Response to the New York Public Library Master Plan

The Committee to Save NYPL

JANUARY 2018

Fig. 2. First floor plan showing existing and proposed major vertical circulation. Three stairways serve the south side (left) and one serves the north (right). Note: NYPL has not provided plans so this diagram is intended to represent what can be assumed from their vague presentation.

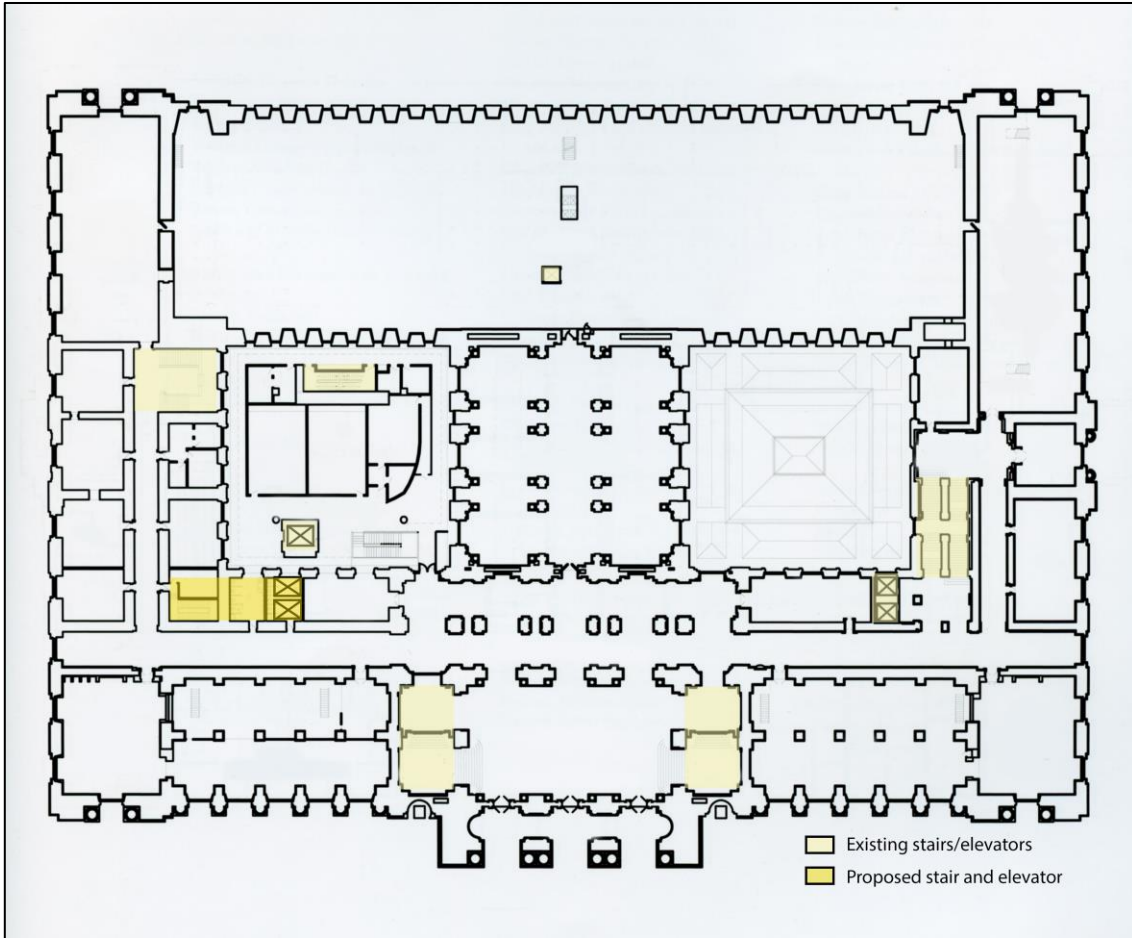
NYPL proposes to cut a new entrance into the landmarked exterior at 40th Street and add a new stair and elevator bank adjacent to the south hall. This is a radical alteration to the structure and design of the building. The stated justification for such significant change is the wish to accommodate future programs for high school and university groups and to provide an employee entrance.

Carrère & Hastings designed a beautiful stair in the south hall, and though it has been insensitively altered and remains closed to the public, it is still there to serve every floor (Fig. 1). Library officials contend this stair is cut off from the rest of basement floor by the freight entrance. A more modest stair connecting the basement to the first floor could overcome this inconvenience while taking advantage of the existing and plentiful stairs in the building (Fig. 2). A master plan with such extravagant and redundant circulation might indicate undisclosed priorities. It may be that the new stairs and elevators are aimed primarily at more efficient access for caterers at the many private functions held at NYPL.

Instead of these costly alterations, CSNYPL urges library officials to give priority to upgrades of the slow and inefficient elevators in the north hall that inconvenience readers and researchers. Additionally, the two unused Astor Hall entrances on Fifth Avenue could be opened to ease congestion, especially as the bag checks there have created bottlenecks.
